## Wards Lake Park Phase 1 & 2 Improvements

City of Lakewood Parks and Recreation

### ADDENDUM NO. 1

November 13, 2024

SHEET C-510 – CIVIL DETAILS

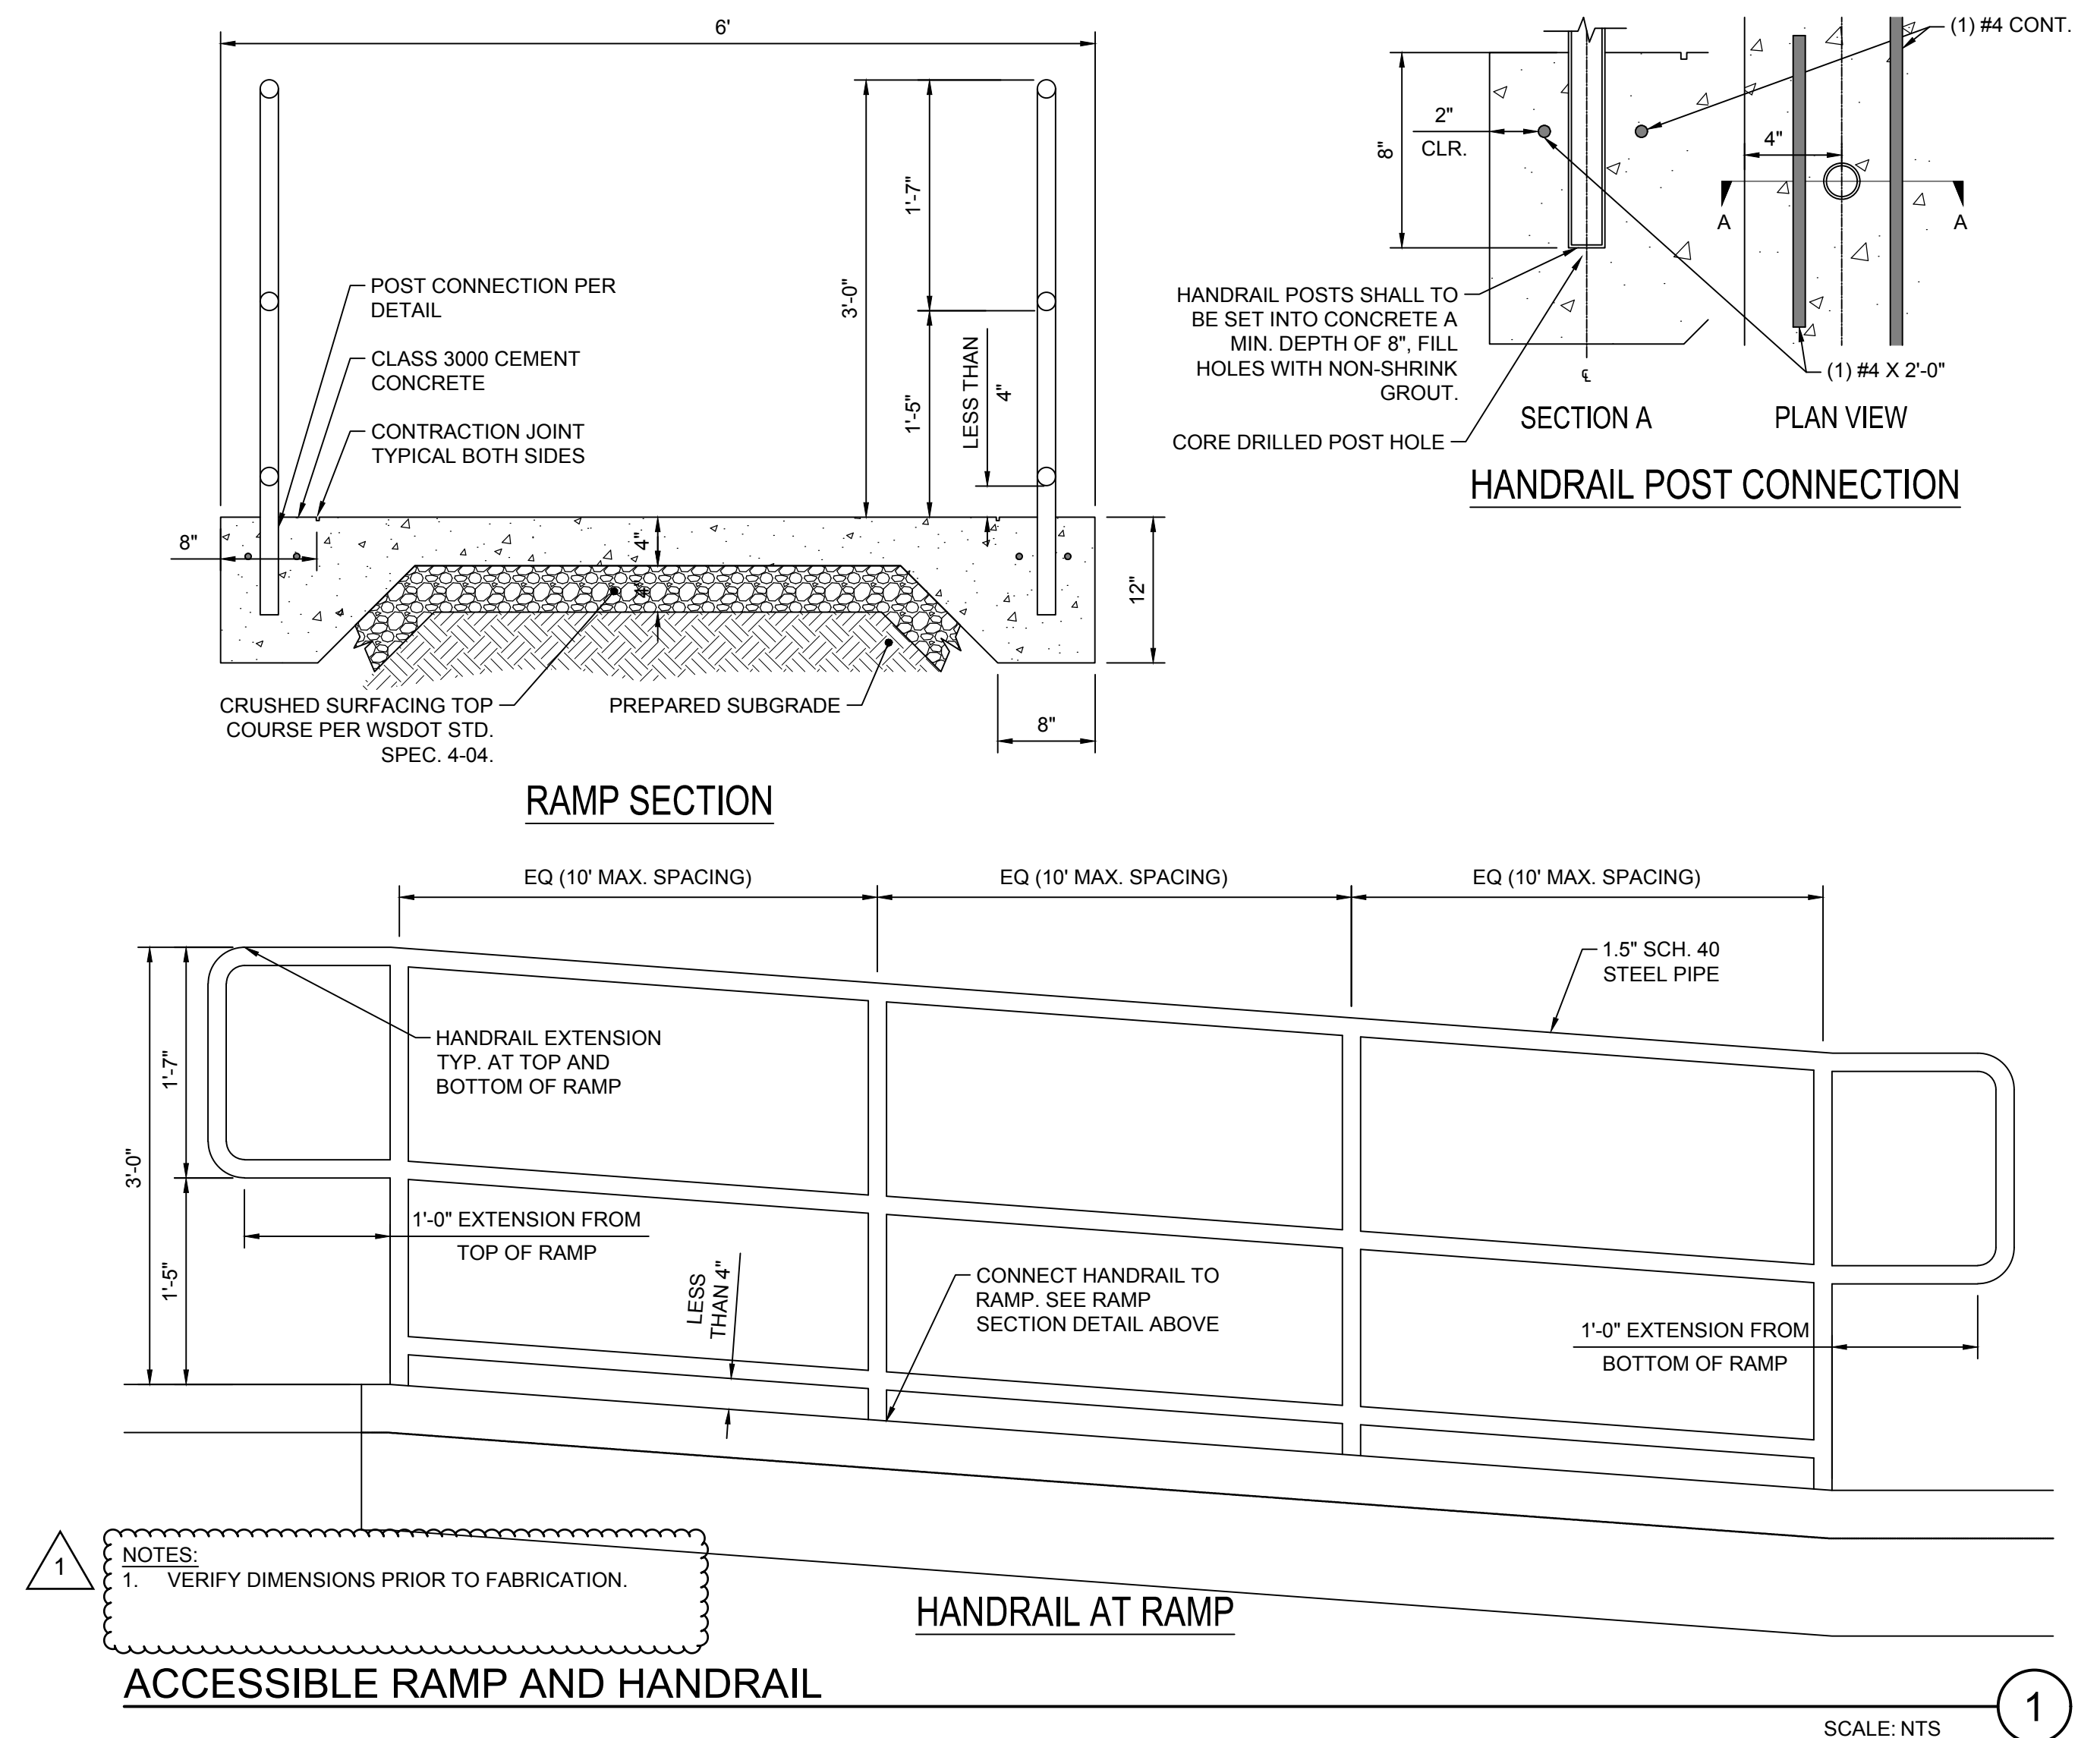
**REVISE** detail 1 to remove the reference to powder coating finish

C-512

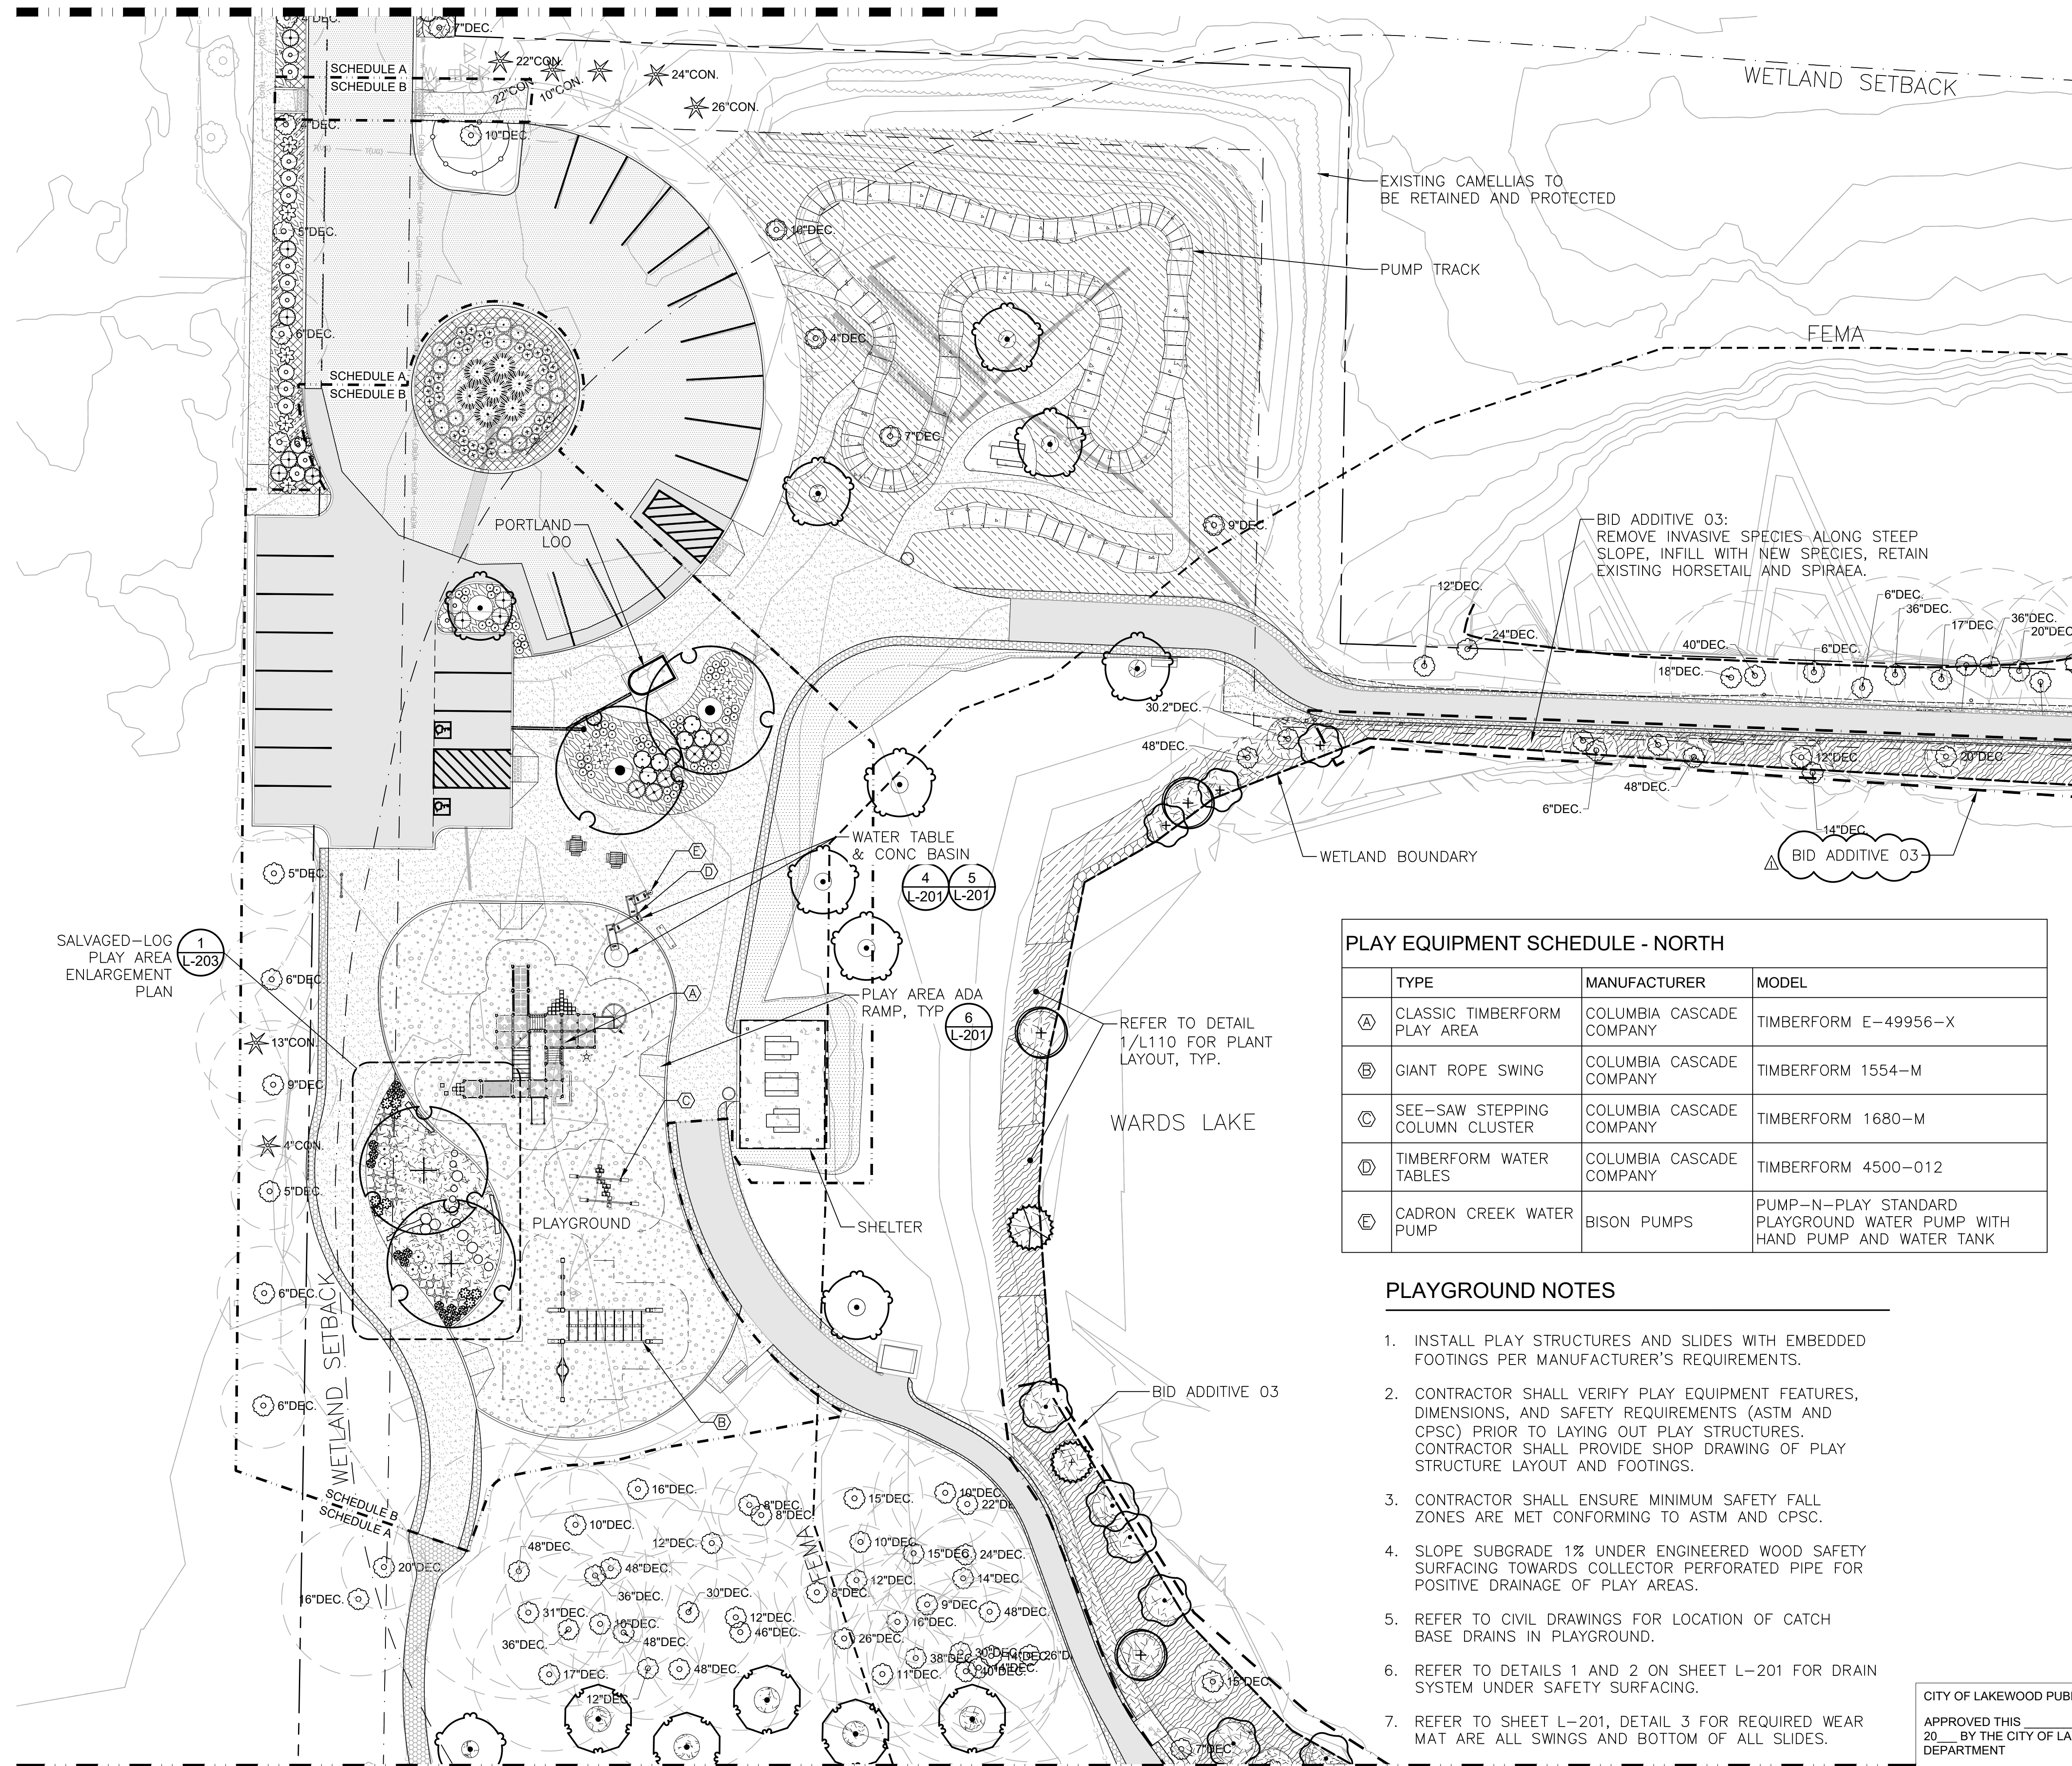
**REVISE** detail 1 to clarify post connection details and remove the reference to powder coating finish.

**L-102.1**

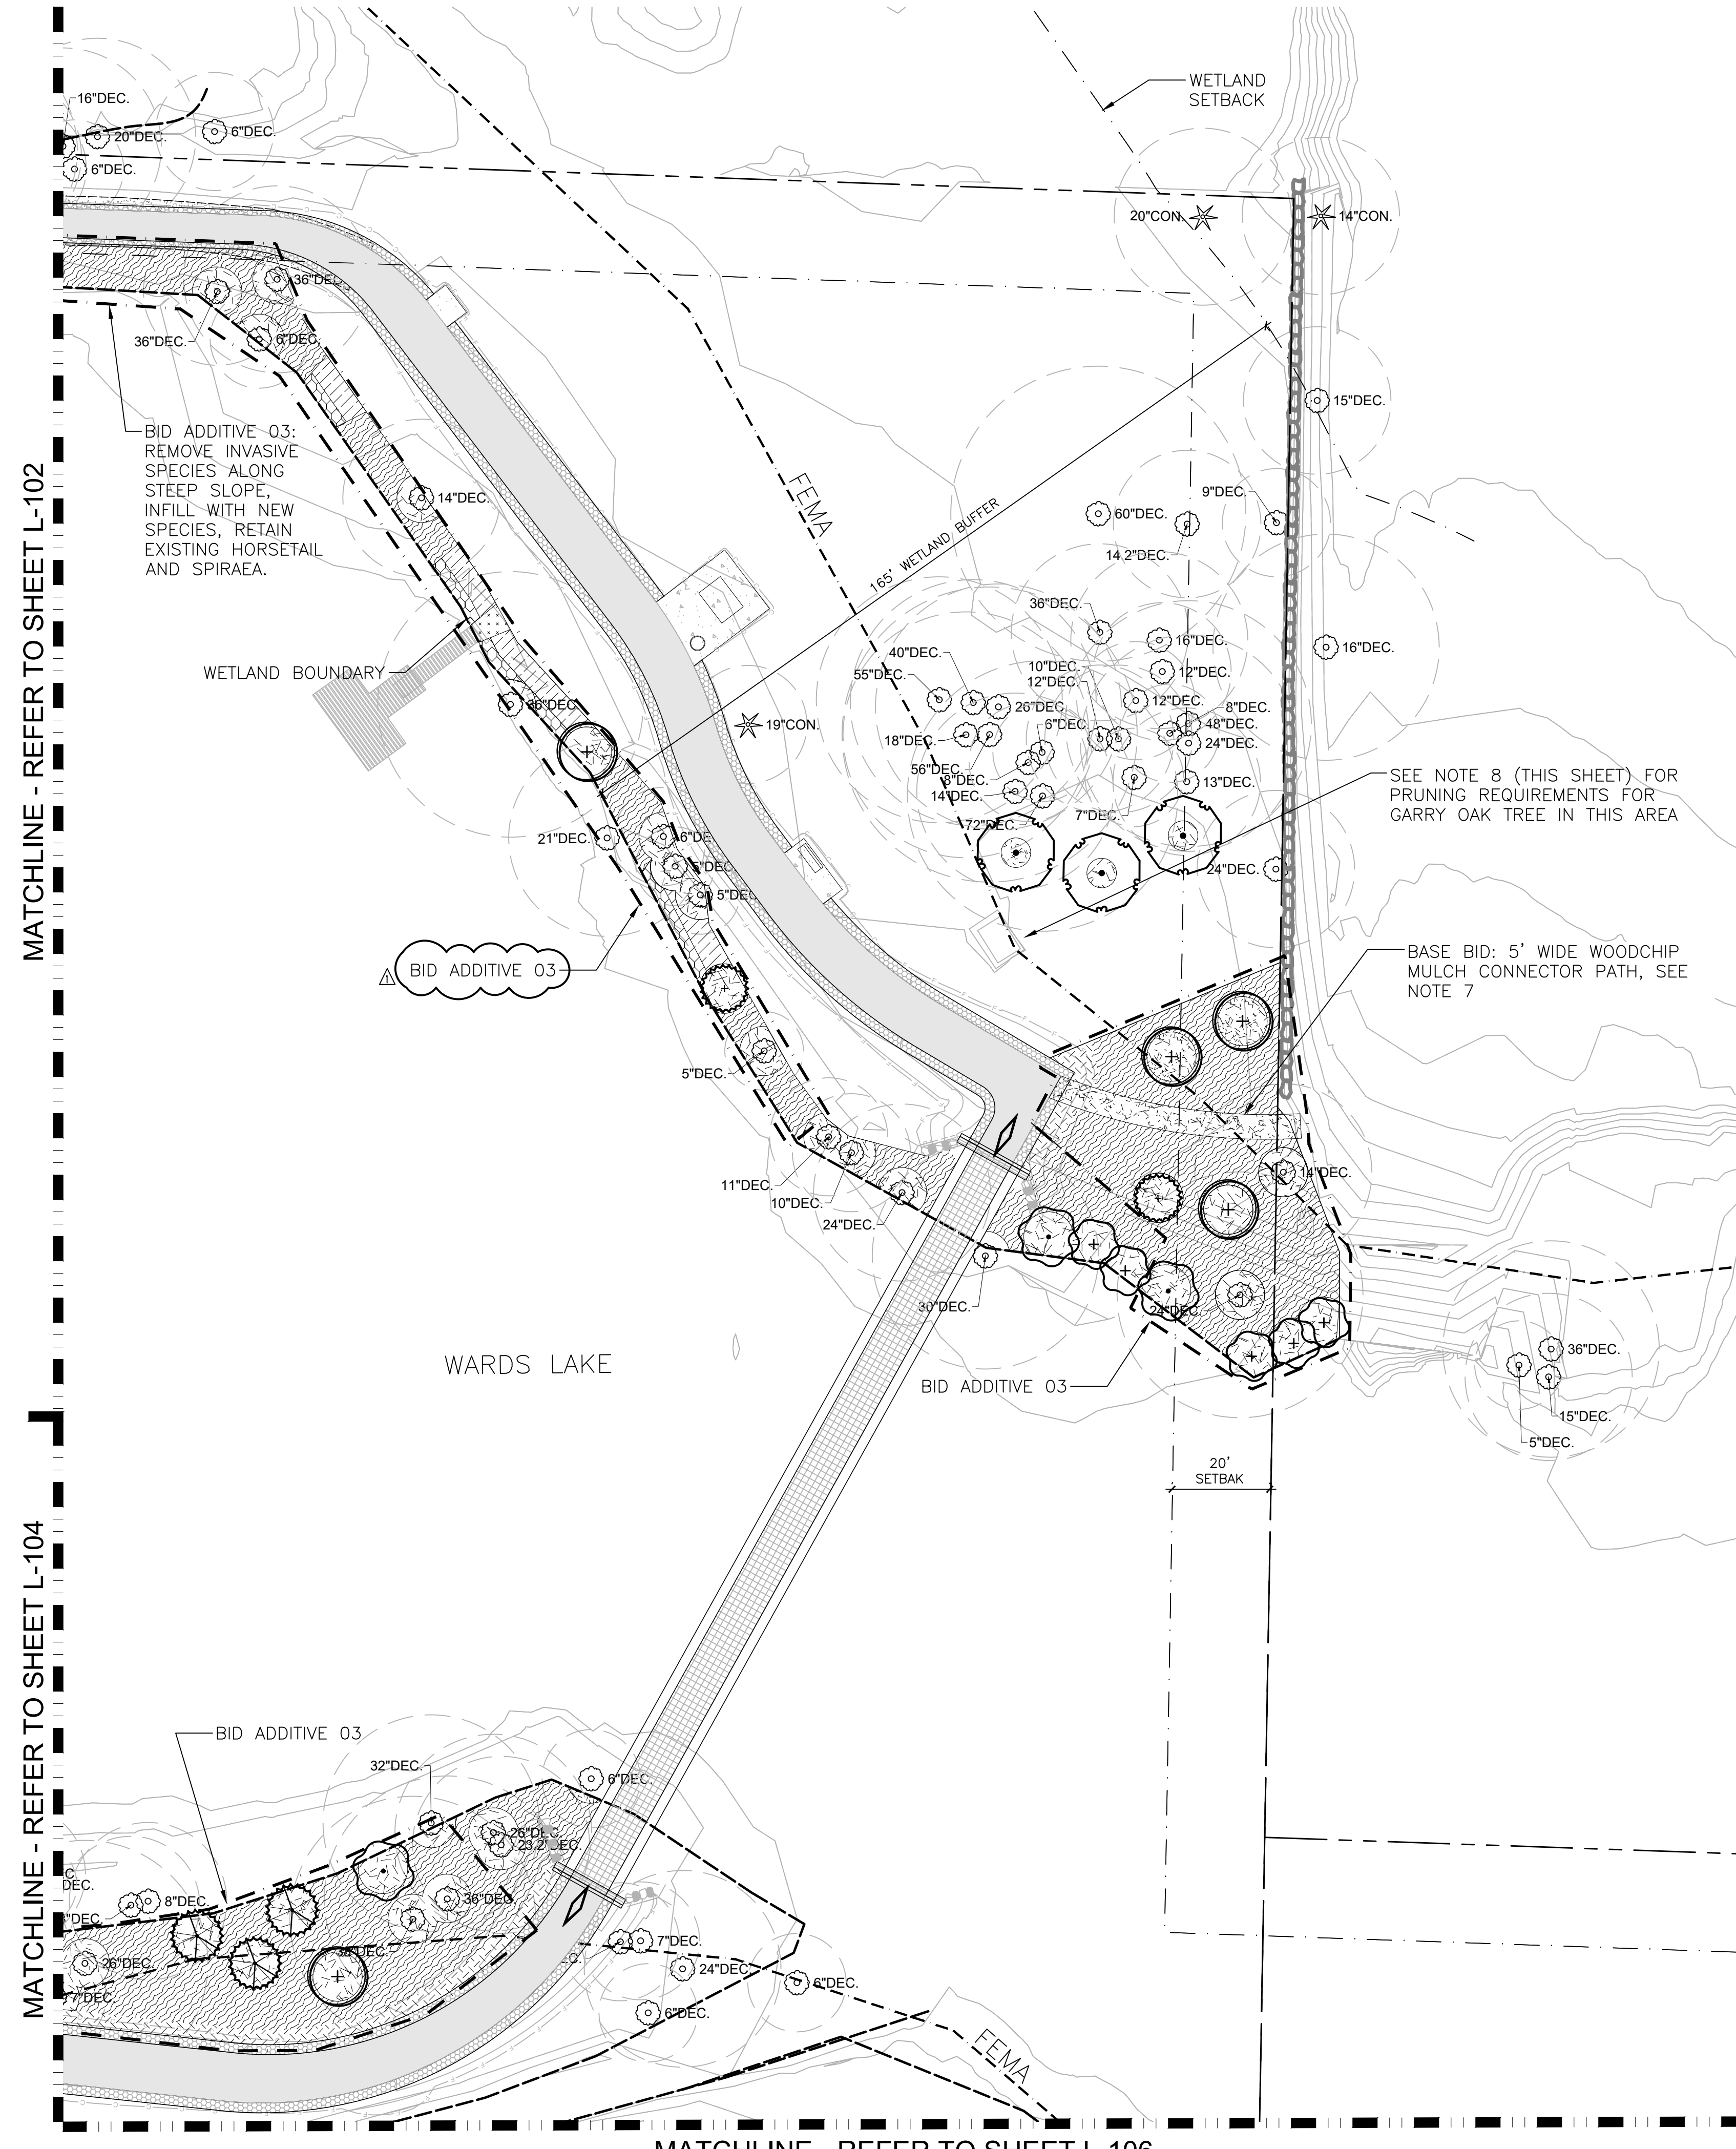
**REVISE** plant symbol in legend.
